DA NO: DA-2021/307
ADDRESS: 1 DORSET ROAD, NORTHBRIDGE NSW 2063.
PROPOSAL: SUPPLEMENTARY REPORT - INSTALLATION OF INCLINATOR AND ASSOCIATED WORKS.
RECOMMENDATION: APPROVAL
ATTACHMENTS: 1. ASSESSMENT
2. SCHEDULE OF CONDITIONS
3. ORIGINAL NOTIFICATION MAP
RESPONSIBLE OFFICER: RITU SHANKAR - TEAM LEADER
AUTHOR: ANA VISSARION – SENIOR DEVELOPMENT ASSESSMENT OFFICER
REPORT DATE: 22 AUGUST 2022
REPORT FOR: 30 AUGUST 2022

1. PURPOSE OF REPORT

Excerpt – proposed inclinator and adjoining 3A Dorset Road - Living Level - plan

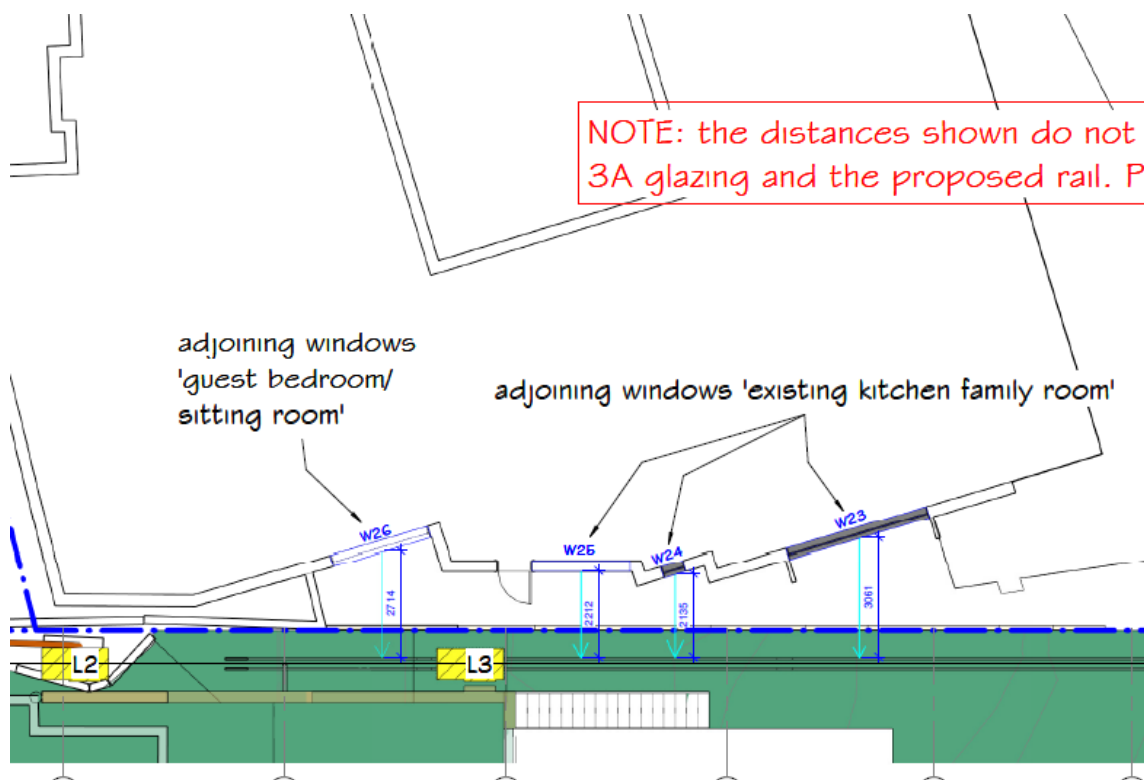
The amended plans include now the dwelling approved and under construction by DA-2020/233/A at 3A Dorset Road, Northbridge.

Windows on western elevation at 3A Dorset Road are at most levels associated with spaces that do not require additional protection of privacy, except for windows at the Living Level.

Excerpt - elevation of proposed inclinator and Western elevation of adjoining 3A Dorset Road

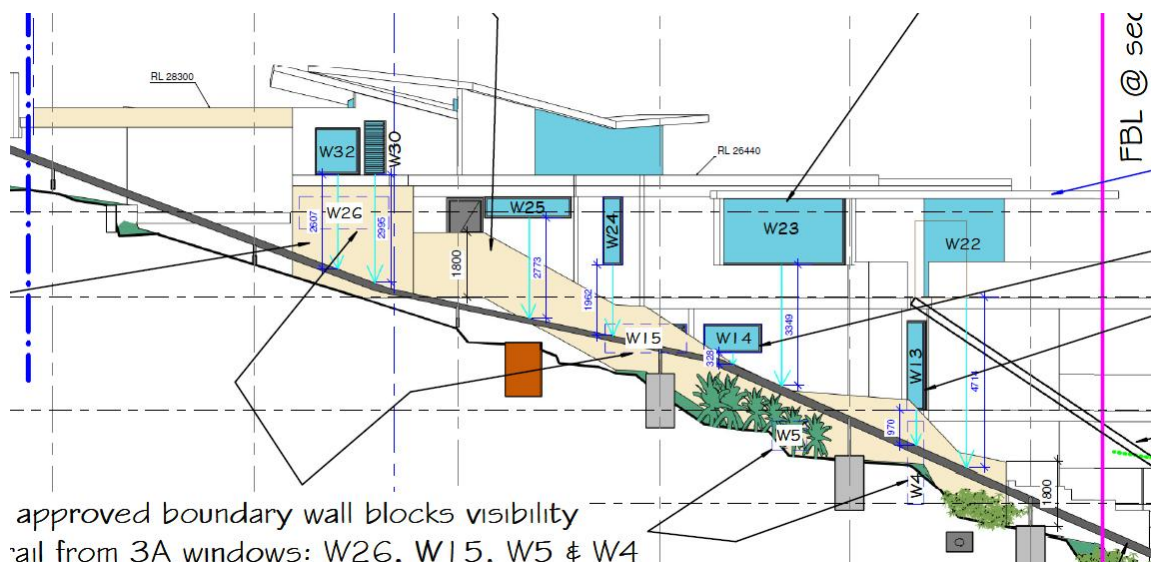
The Living Level (middle level on elevation) contains windows (guest bedroom, kitchen and family room). Privacy is ensured for most of these windows, due to boundary walls and locations/size of windows. One (1) window is of interest, marked on plans and elevations to be W23. This large window is oriented at an angle towards the common boundary and overlooks the rear yard of the subject property. Notwithstanding that, W23 is approx. 3m away from the inclinator rails and approx. between 2.2m to 4m above the level of the inclinator rails.

Taking into account the height of the inclinator cabin, there will be no overlooking possible or privacy issues generated by the cabin passing by, even if the cabin will be open, with no privacy walls.

proposed railcar detail by DKC RAILCAR DETAIL (not to scale) Design of proposed cabin

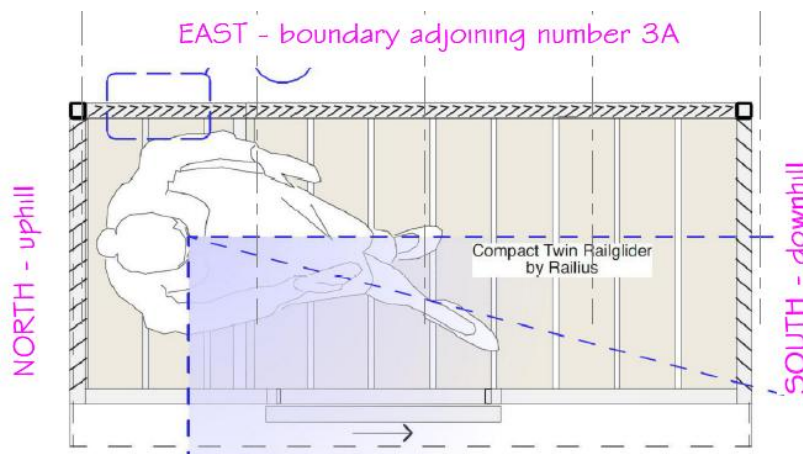
Notwithstanding this, the inclinator cabin is designed with privacy screens on three (3) sides. The Northern and Southern walls of the cabin have privacy screen blades that direct the views away from neighbours, while the Eastern wall has dense blades that do not allow for any views towards adjoining eastern neighbours.

While properties at this location sit on steep foreshore sites where a degree of overlooking is expected and acceptable, the design of the inclinator cabin and the location of the rails in

relation to windows/openings of 3A Dorset Road should be sufficient to maintain the visual amenity of 3A Dorset Road.

The cabin operating on the inclinator shall have permanent, non-removable privacy walls, including the eastern privacy wall. At no time shall the cabin operate if not constructed in accordance with the approved drawings.

Landscape Plan submitted as an amendment of the plan accompanying previously approved DA 2021/6 on the subject site

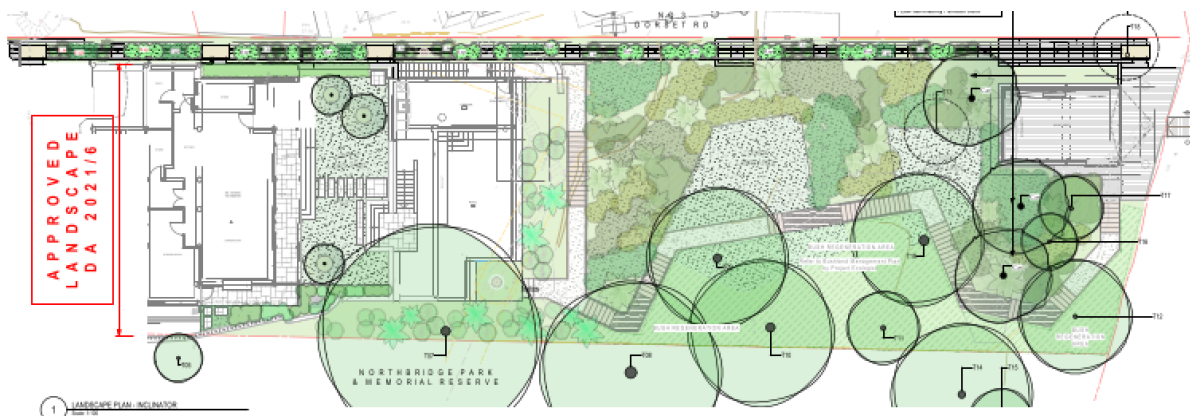
A landscaping plan has been submitted and indicates the variations to the approved landscape plans for DA 2021/6 and provide for screening of the inclinator.

1 x Melaleuca sp. tree is proposed to be removed, a semi mature tree, indicated by the Arborist's report to be in decline. The tree proposed for removal is proposed to be replaced at a rate of 3 to 1, in accordance with Part C9 of the *Willoughby Development Control Plan – Vegetation Management*. The location of the replacement trees is appropriately chosen to be away from main dwelling and on the western side of the property, where it will further screen the inclinator from views from the adjoining Local Heritage Item and will constitute a link between the subject property and the Reserve.

Excerpt from the proposed planting in the inclinator area – typical section

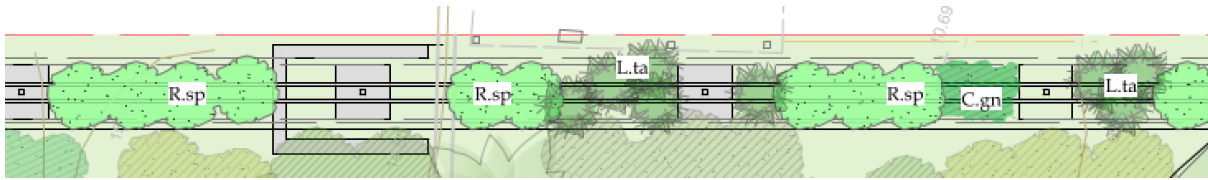
Planting under the rails is proposed where feasible and chosen from non-invasive species. Chosen planting schedule took into account the particularity of the site and the proximity of the Northbridge Park and Memorial Reserve.
